ADDENDUM NUMBER ONE
JENERA WASTEWATER TREATMENT PLANT IMPROVEMENTS
CONTRACT A
VILLAGE OF JENERA, HANCOCK COUNTY, OHIO
PROJECT NO. 10E03007
FEBRUARY 8, 2008
BID OPENING: February 15, 2008 AT NOON

INFLUENT HEAD STRUCTURE

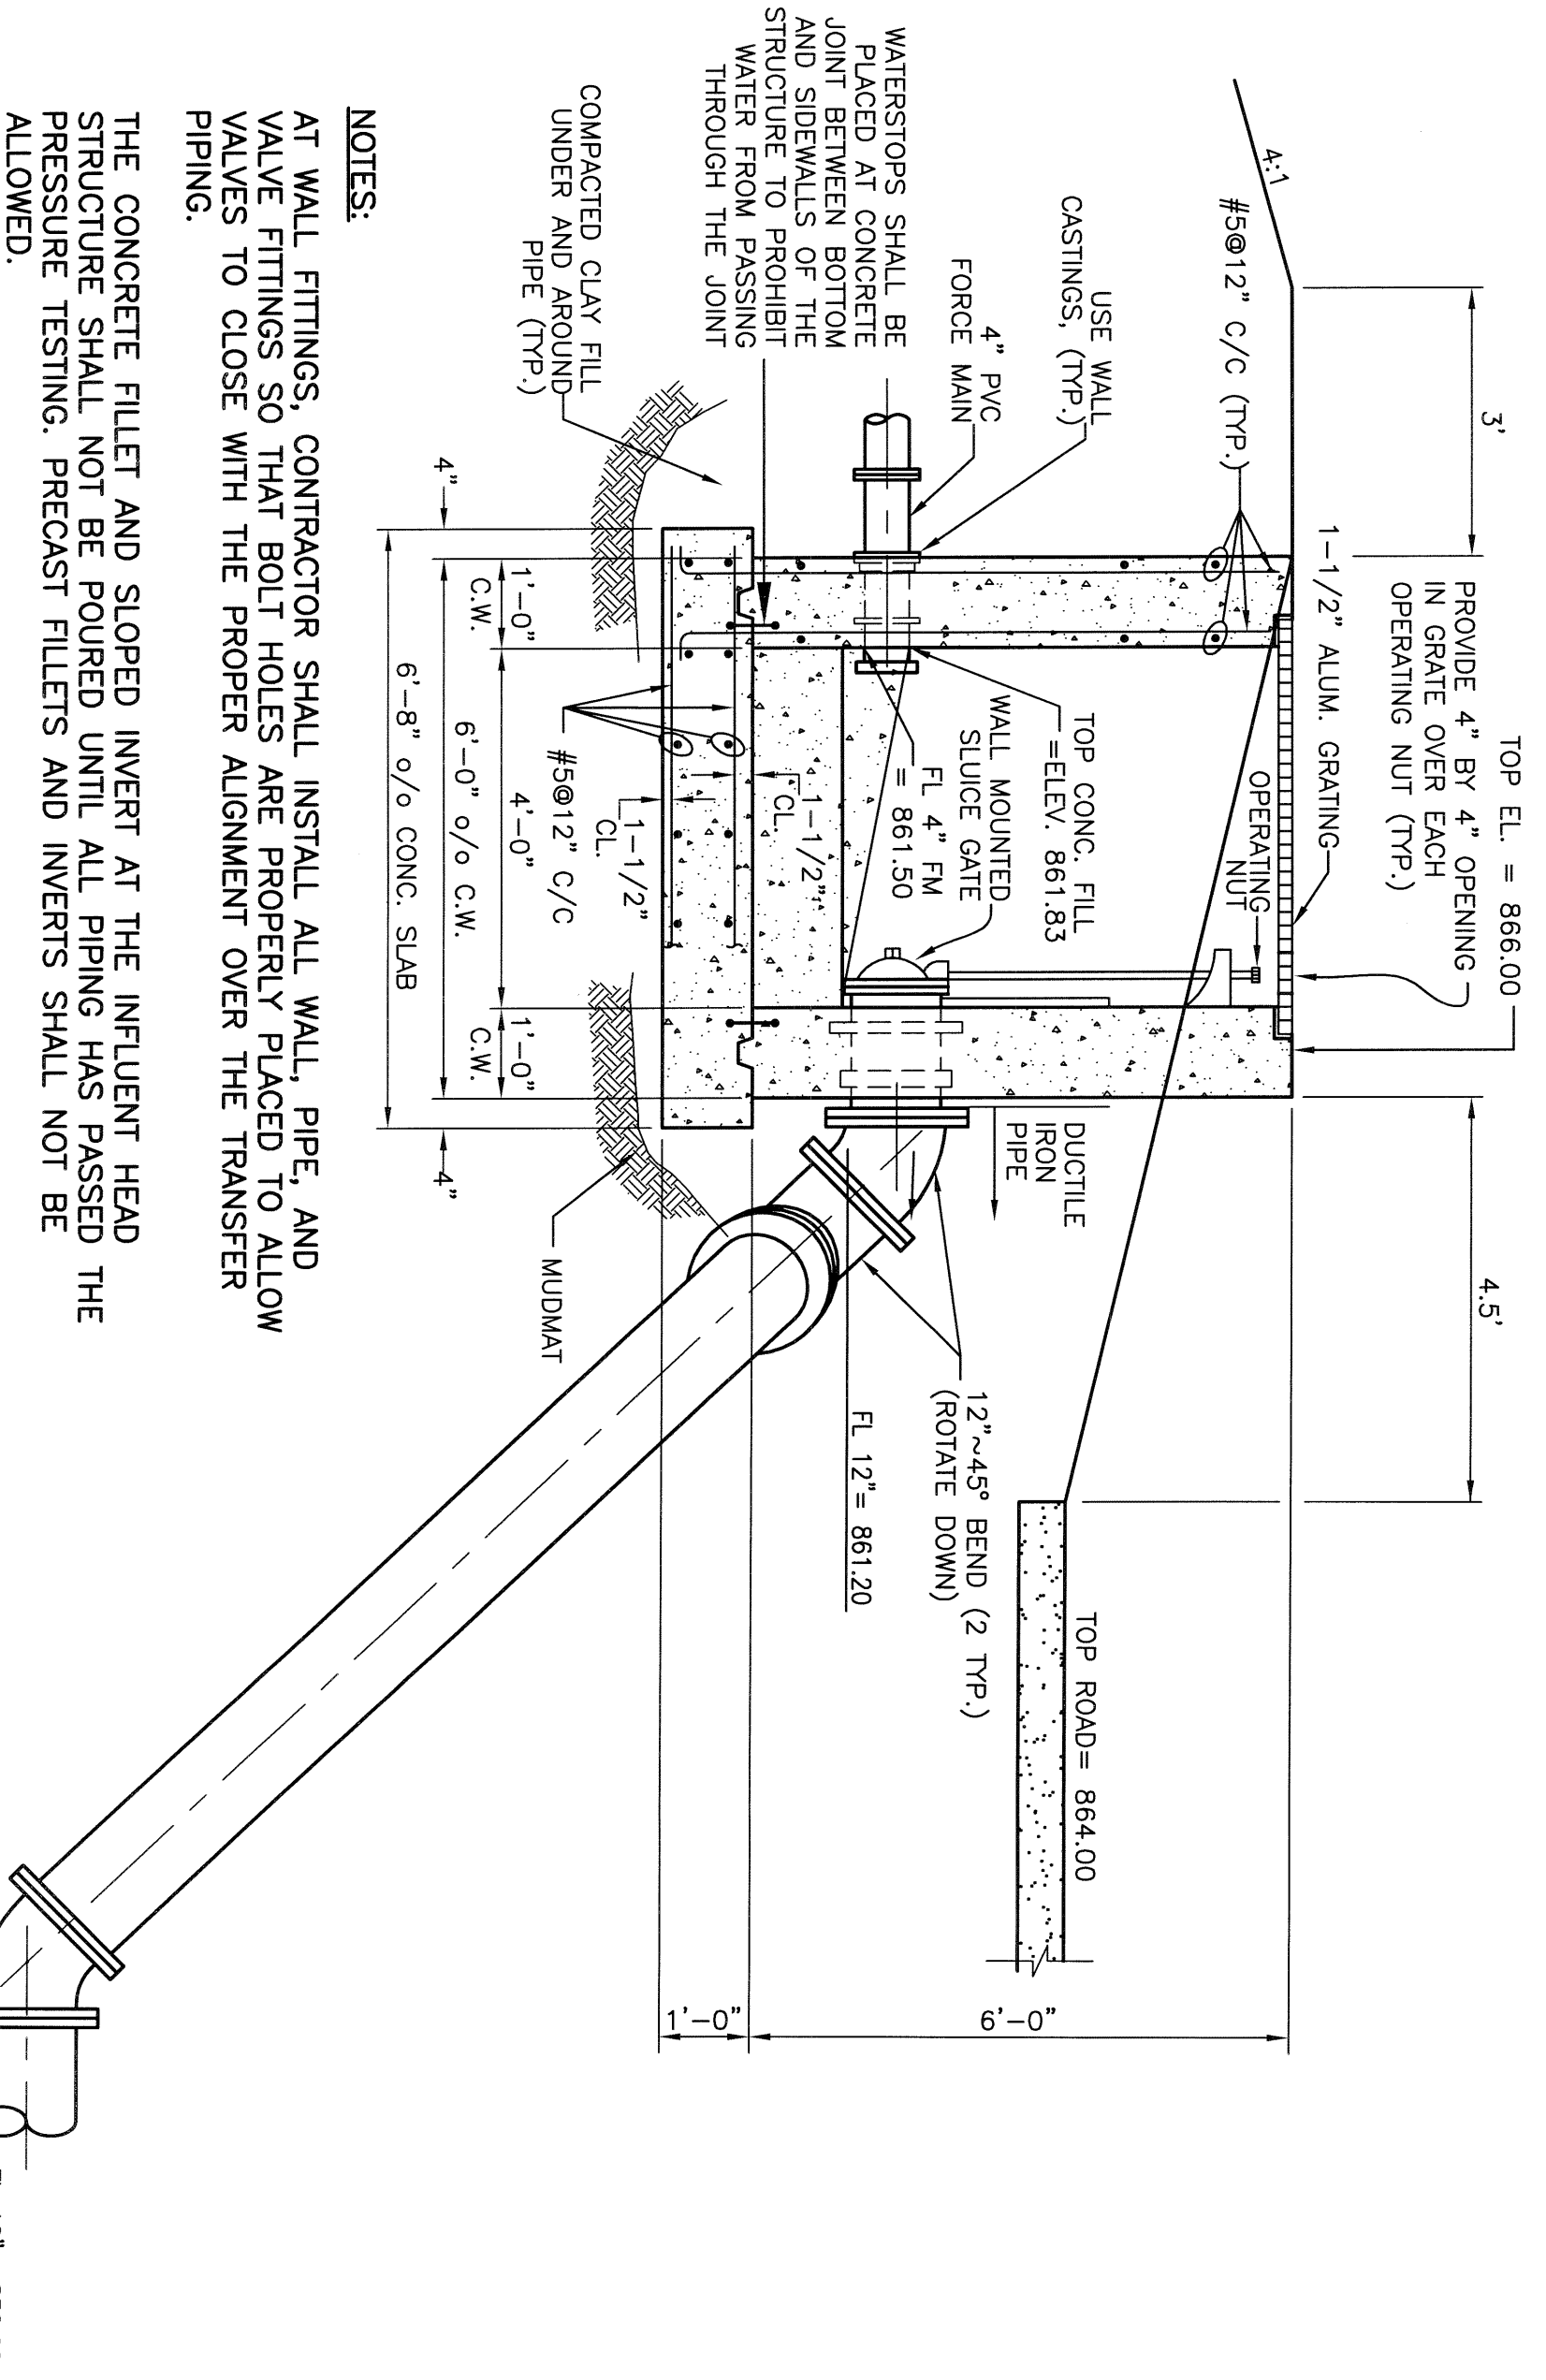
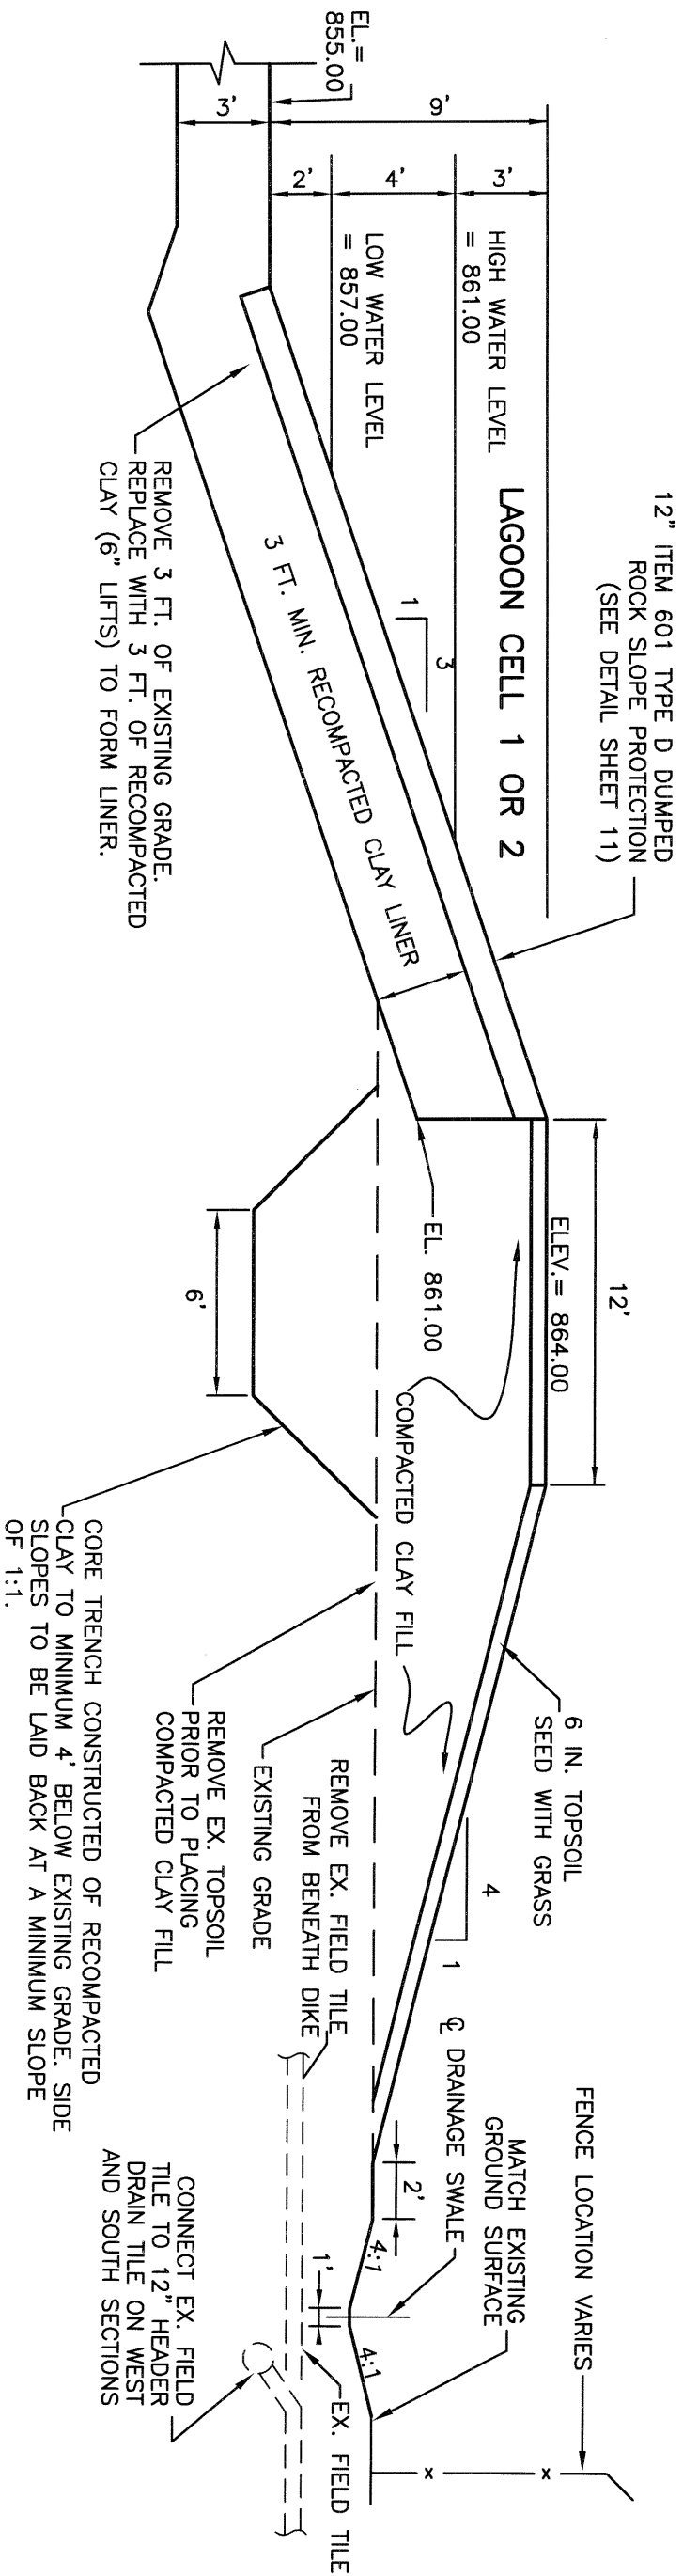
Sheet 9

The two INFLUENT HEAD STRUCTURE details shall be revised at the wall castings and be replaced with the attached two details.

AT WALL FITTINGS, CONTRACTOR SHALL INSTALL ALL WALL, PIPE, AND VALVE FITTINGS SO THAT BOLT HOLES ARE PROPERLY PLACED TO ALLOW VALVES TO CLOSE WITH THE PROPER ALIGNMENT OVER THE TRANSFER PIPING.

THE CONCRETE FILLET AND SLOPED INVERT AT THE INFLUENT HEAD STRUCTURE SHALL NOT BE POURED UNTIL ALL PIPING HAS PASSED THE PRESSURE TESTING. PRECAST FILLETS AND INVERTS SHALL NOT BE ALLOWED.

SECTION 3
NOT TO SCALE

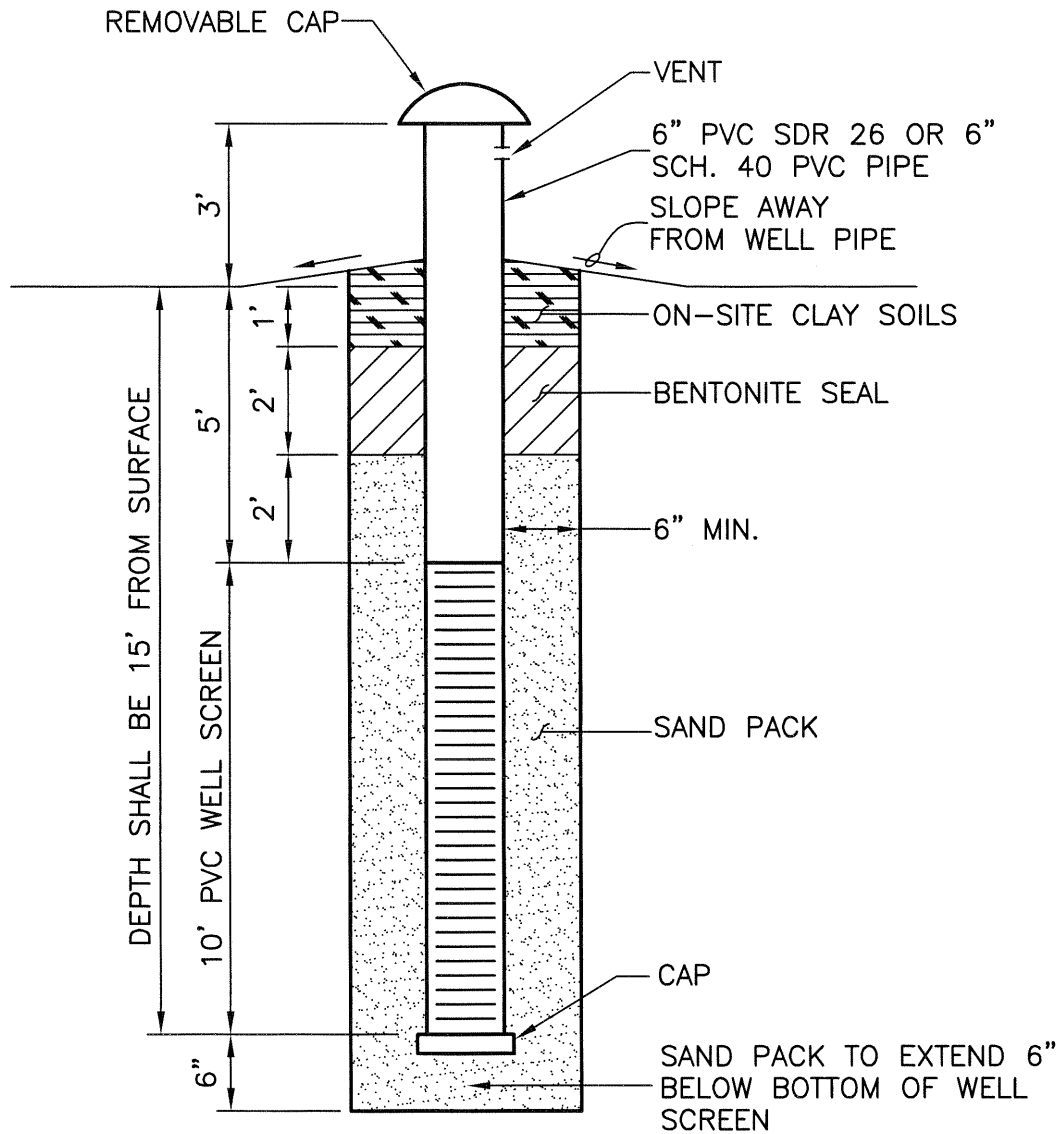
Sheet 12

On SECTION 3, the detail shall be revised to show the Top of Berm to be 3 feet above the High Water Level and be replaced with the attached detail.
